SUBJECT: Forwards Draft responses to NRC Questions 231.1 to 231.5 per
 810803 request for addl info. Three oversize drawings encl
 Aperture cards will be available in PDR.

Subject: Palo Verde Nuclear Generating Station
(PVNGS) Units 1, 2 and 3
Docket Nos. STN-50-528/529/530
File: 81-056-026, G.1.10

Reference: Letter from R. L. Tedesco, NRC, to E. E. Van Brunt, Jr.,
dated August 3, 1981, Subject: Request for Additional
Information (Geology)

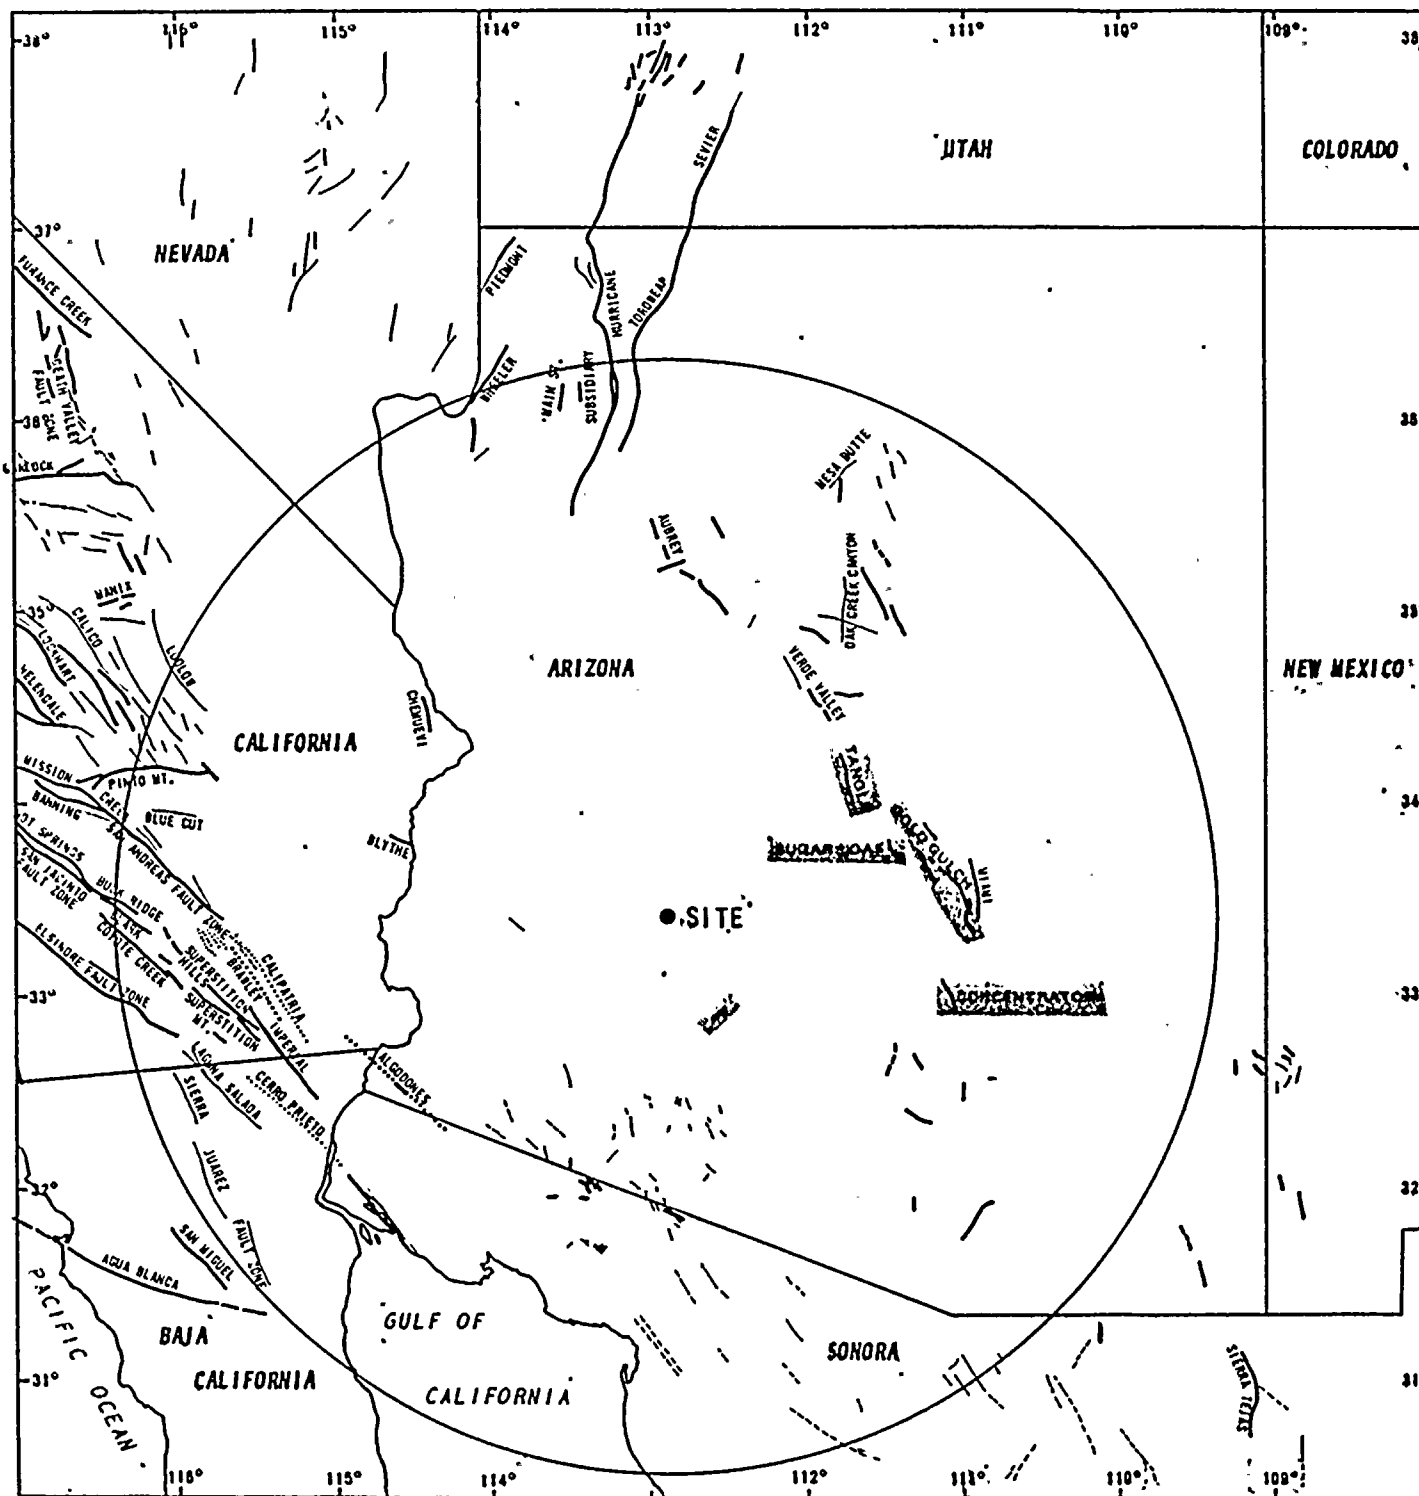
Cloran's interpretation of faults within the Tonopah Basin is based on consistently steep gravity gradients and a few abrupt magnetic anomalies. The basin bounding faults interpreted from gravity data are shown in Section (plate 8) using two interpretations of the geophysical model. Model 2, shows the most faults and has been discussed here as the most conservative alternative. Unfortunately, there is no plan which shows the interpreted length and orientation of northwest basin bounding faults between the three cross sections. Similarly, there is no section or plan showing the location, orientation or length of the northeast trending fault along the "Tonopah Nose" or of the northeast faults defining the abrupt, high-low magnetic anomalies. These locations must be inferred from the text description. Figure A is a reduced version of Plate 4 showing our interpretation of Cloran's faults described in the text and cross sections. In addition, we have superimposed the location of the inferred and geophysical faults from FSAR Figure 2.5-8 for ease of comparison in the following discussion.

The PVNGS geophysical and subsurface investigations concentrate on the southeast edge of the Tonopah Basin closest to the site. Cloran's survey overlapped the northern edge of the PVNGS investigation and covered the remaining southern two-thirds of the entire valley. The two southernmost faults (A and B, Figure A), which were interpreted as basin bounding structures in the FSAR appear in good alignment and form a reasonable correlation with Cloran's basin bounding faults farther northwest (i.e. faults F & G). Fault F, which marks the change in gravity gradient from about -6 to -12 milligals, seems the most consistent structure and possibly correlative with fault B of the PVNGS investigation. Sumner (personal communication, 1981) has commented that Cloran's gravity contours suggest another alternative interpretation, i.e. a structural change along the 0 milligal line which roughly parallels the northwest trend of the valley. This inferred structure would project into the vicinity of faults A and B and also might be correlative with them. Therefore, a complete acceptance of Cloran's work would suggest at least one and possibly two faults (A and B) may be longer than shown on FSAR Figure 2.5-8. Another alternate interpretation could postulate one fault which might correlate to faults A or B.

Along the northern Tonopah Basin, Cloran has interpreted two bounding faults (H and I) at the change in gravity gradient near the -10 milligal contour. Fault I roughly follows the -10 milligal contour and appears to correlate among all three cross sections. The correlation of fault H among all three cross sections. The correlation of fault H among all three cross sections requires cutting across one strong prominent gradient near section C-C' (Figure 8), therefore fault H may not be as continuous as fault I. The FSAR Figure 2.5-8 shows a geophysical fault (fault E) about two or three miles north of Cloran's fault (H and I). The existence and location of fault E was based on a single gravity profile performed during the PVNGS investigation which was supplemented by regional gravity data and regional geology. Fault E was interpreted along the steep gravity gradient along the south margin of the Belmont Mountains.

The "Tonopah Nose" was interpreted by Cloran from the abrupt kink in gravity contours in the southwest corner of the basin (Figure A). Based on the text description, there was a fault interpreted along the aligned contours of the kink. Although the original gravity readings and station data are not available and have not been analyzed, it is clear that the contours have been pulled out of position by an anomalous reading on one station. This leads us to suspect the accuracy of the station readings or elevations and, as a result, to question the existence of the "Tonopah Nose".

The shorter, east-west trending geophysical faults near the center of Tonopah Basin (faults C and D) correlate, in one instance, with a basin fault shown on Cloran's section A-A' (Plate 8). Fault D has no obvious correlation to any structure shown on Cloran's section B-B'. Fault C, if projected west, would generally align with several short northeast faults that Cloran interpreted at the southwest margin of the Basin, however, there is no basis for a reliable correlation.

Cloran's work refined the shape and location of the northern basin contours and, as a result, permits a more refined interpretation of basin faulting. Upon reviewing Cloran's work, we agree that the data suggests a range bounding fault along the northern Tonopah Basin. However, we favor placing the fault in the areas of the steepest gravity gradient, i.e. approximately along the -4 milligal

contour (Sumner, 1981, personal communication). This latter interpretation would place the range bounding fault about 1 mile south of and slightly subparallel to fault E and about one or two miles north of faults H and I. Although the locations of the different interpretations of range bounding faults may vary by a few miles, the general concept of a bounding fault along the northern edge of the Tonopah Desert has been accepted and considered in the FSAR. In addition, the FSAR has considered a hypothetical fault from published tectonic maps along the entire southern boundary of the Belmont Mountains (FSAR Figure 2.5-8).

In summary, it can be said that Cloran's work has expanded the geophysical interpretation of the Tonopah Basin, and in terms of the basin bounding faults nearest the site, has shown that one of the southern basin faults might be continued 8 to 10 miles farther northwest. The interpretations between Cloran and PVNGS studies regarding faults forming the north margin of the Tonopah Basin agree in principle as to the existence of a basin bounding fault, but these interpretations have placed the faults at different locations (a few miles apart) and slightly subparallel in orientation. Cloran's work has identified some short northeast trending faults near the southwest edge of the basin which would project toward Saddle Mountains. The latter faults are the only really new interpretations introduced. It is important to note that these interpretations of northeast trending faults are somewhat suspect because 1)

FIGURE 2-5-6

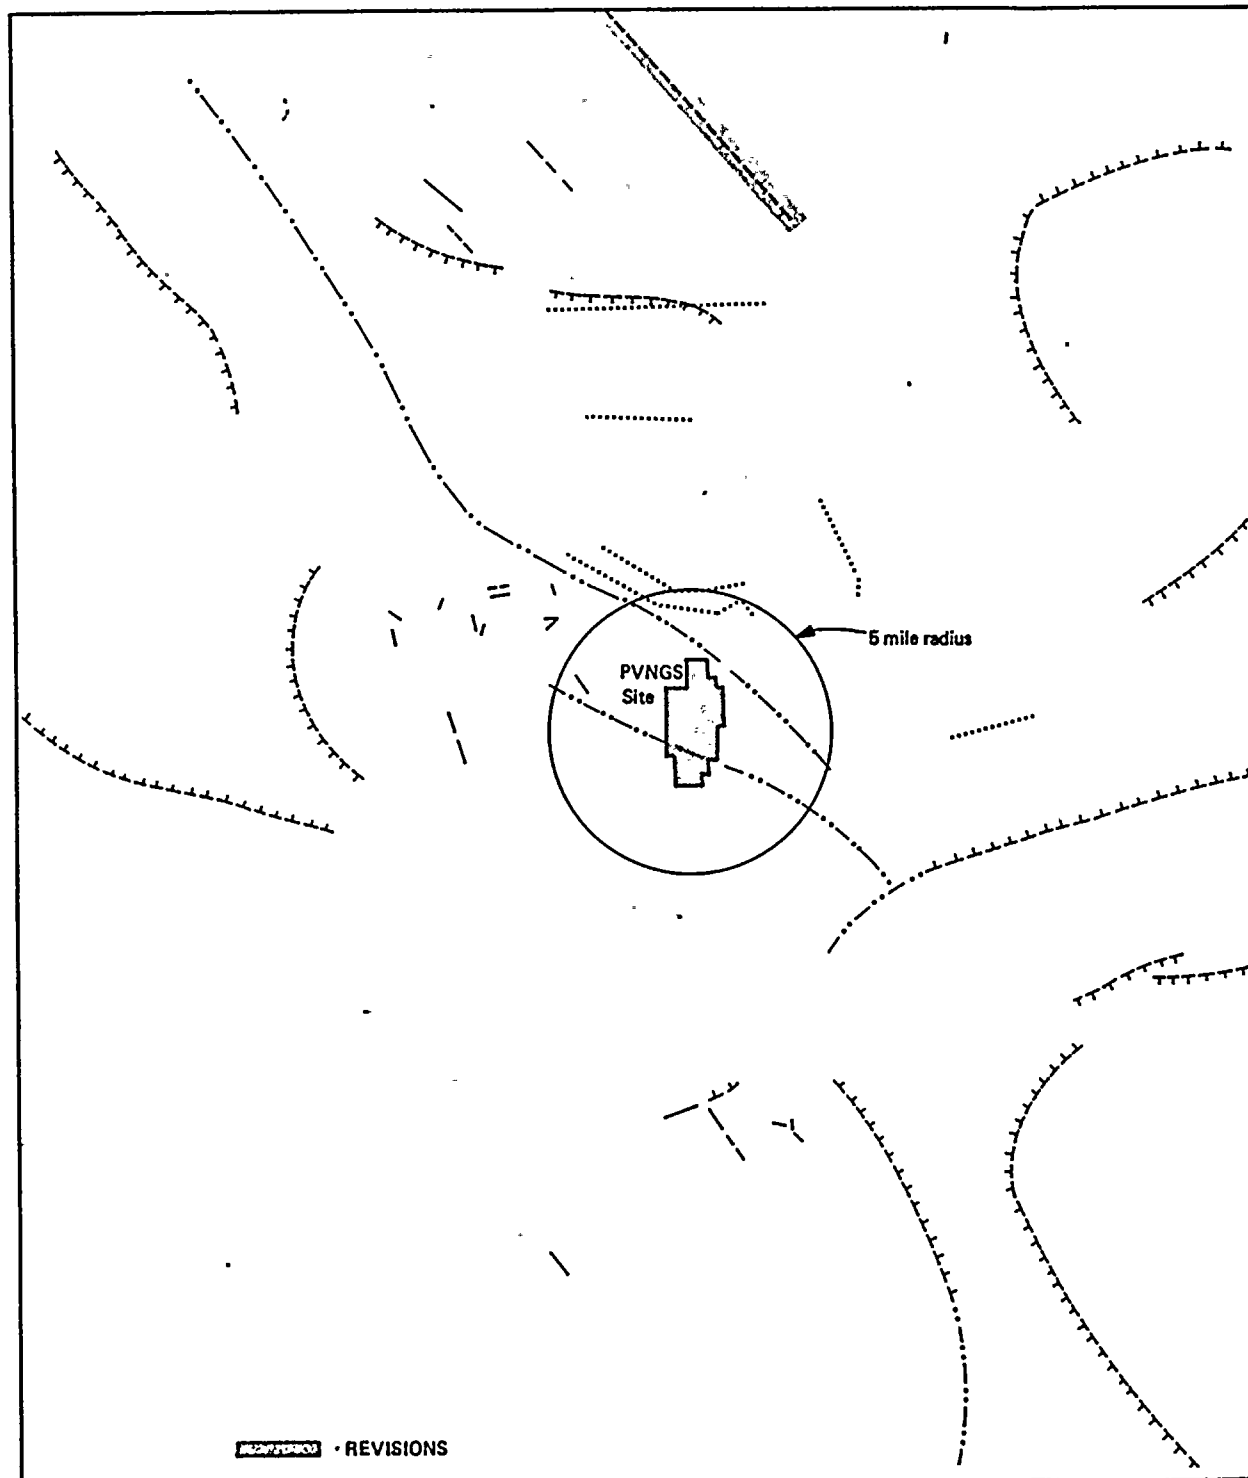
Describe the basis used for categorizing the fault (see FSAR Figure 2.5-6) in the Sand Tank Mountains area some 35 miles SE of the Palo Verde site as older than 500,000 years.

The weight of line used to depict the age of the fault near the Sand Tank Mountains is a drafting error. In the absence of any detailed geologic investigations, we consider the Sand Tank fault as younger than 500,000 years and the FSAR Figure 2.5-6 will be modified accordingly.

Since the exact age within the Pleistocene has not been determined and no detailed analysis is available, no definitive statement can be made regarding the capability of the Sand Tank fault. However, for this analysis we have assumed it is capable. In terms of site safety, the existence of the Sand Tank fault,

about 35 miles south of the site, is not considered significant because of the very conservative model used to establish the seismic design for PVNGS. The Sand Tank fault is too short and too distant from the site to represent a surface faulting hazard or to exceed the Safe Shutdown Earthquake. Therefore, there is no impact to the seismic evaluation of the site by assuming that the fault is capable.
